## CONWAY RETAIL 1627 CONWAY ROAD

### SUMMARY

SHEET 3 OF 3

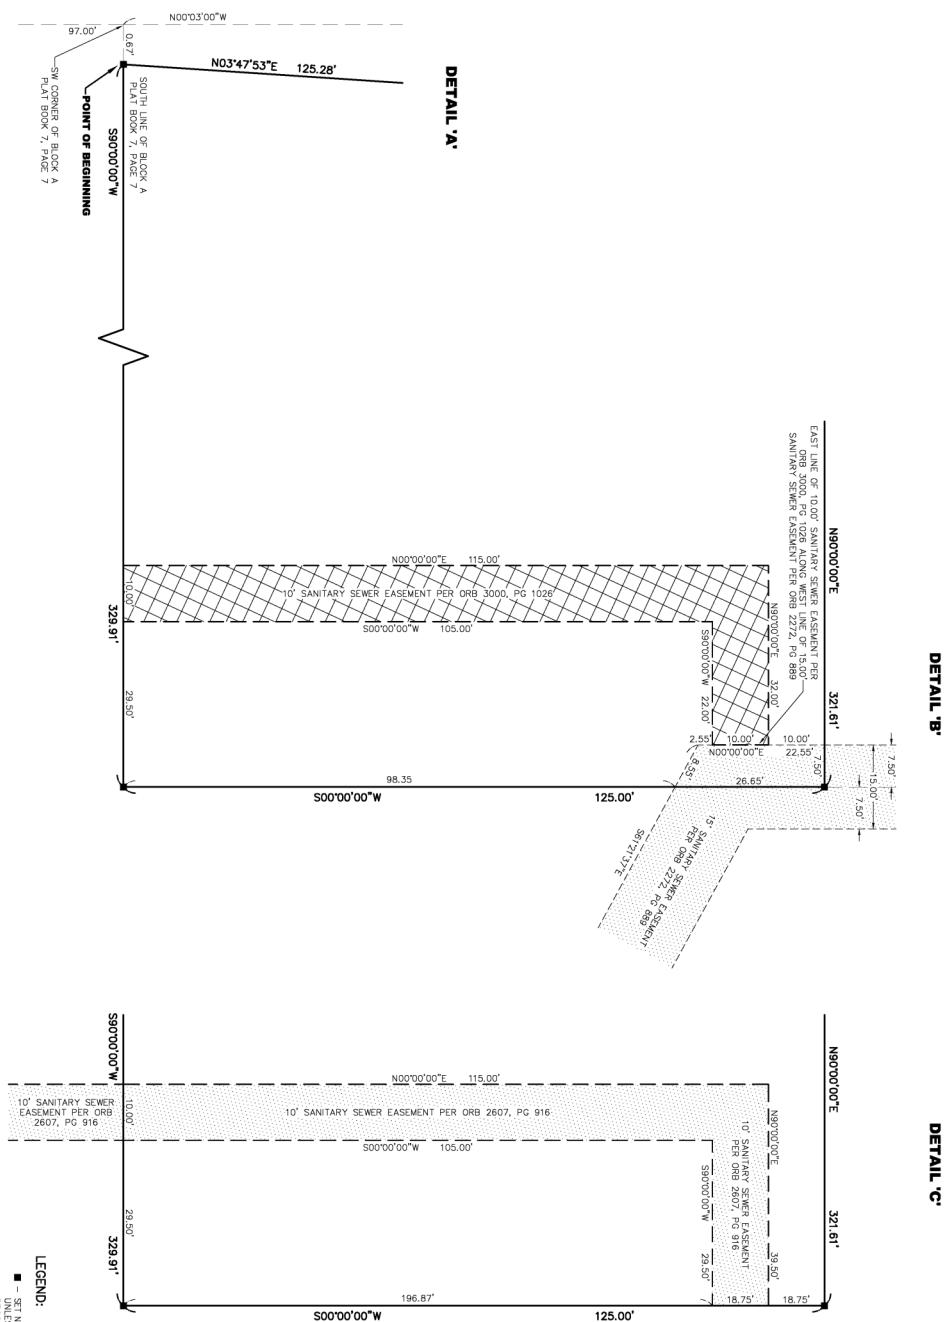
1. Sheet 3 of 3 is missing the north arrow.

- Sheet: (Plat) The 5' sidewalk easement isn't shown on the Plat.
  - Sheet 3: (Plat) The scale and north arrow are missing.
  - Field Review has not passed. Email Dean Hill and copy me to schedule future field checks. Dean can be reached at dean.hill@cityoforlando.net. FS 177.091(7)

**LEGEND:**

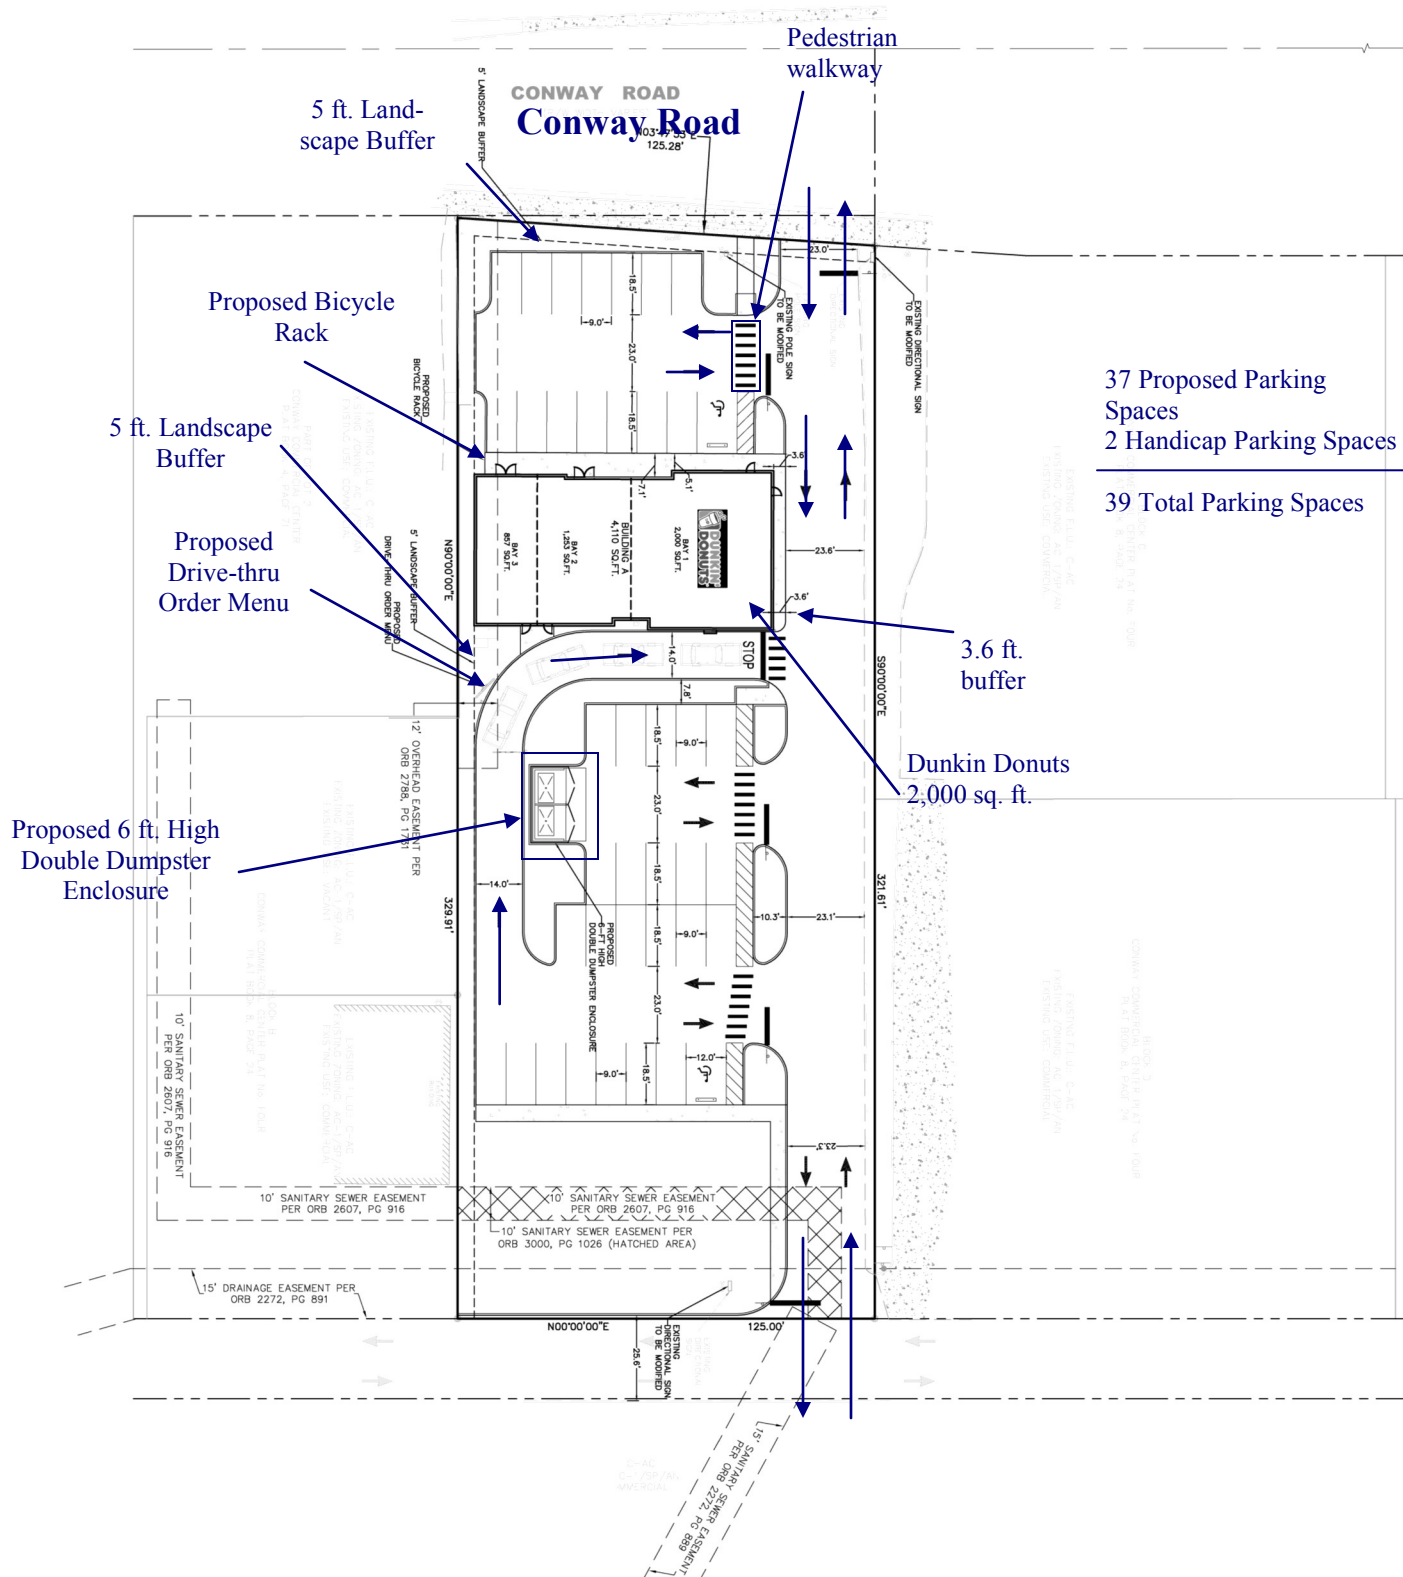
- Sheet: (Survey) Legend missing abbreviations (M),PB,PG,R/W,ORB,CL.
  - Sheets: (Survey & Plat) The dimensioned remainder is missing on Lot 2 PB 4 PG 71.
